Modification Bulletin

Model: Mojito Finisher SR740 Date: 06-Jun-00 No.: MB312001a

Modified Article: B	all Bearing	Prepared by: M. Tsuyuki		
From: Technical Ser	vices Dept., GTS Division			
Reason for	☐ Parts catalog correction		ange	☐ To meet standards
Modification:		☐ To improve	e reliability	()
	☐ Part standardization	☐ Other

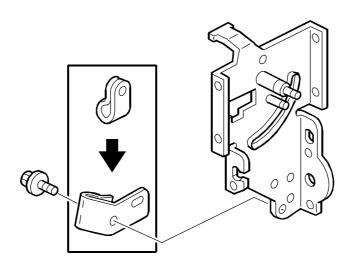
The shape of the clamp for the stapler harness has been changed as shown below to ensure proper orientation of the harness.

Old part number	New part number	Description	Q'ty	Int	Page	Index	Note
11050062		Nylon Clamp – 6n	n - n-1	X/O	19	104	
	B3124160	Harness Clamp	0 - 1	70	19	*43

Harness: Stapler Tray: Motor

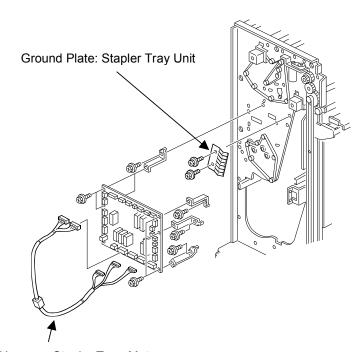
To further minimize the effect of electrical noise, the following parts have been added to the stapler tray.

- 1) Ground Plate
- 2) Ferrite Core (added to the motor harness)

Old part	New part	Description	Q'ty	Int	Page	Index	Note
number	number						
	B5861165	Ground Plate: Stapler Tray Unit	0 - 1		33		
B3125304 -		Motor harness – Stapler Tray	1 - 1	X/O	33	2	
1	B 5865306	Harness: Stapler Tray: Motor] '-'	7/0	33	2	
04513006B		Tapping Screw - M3x6	n – n+2		33	105
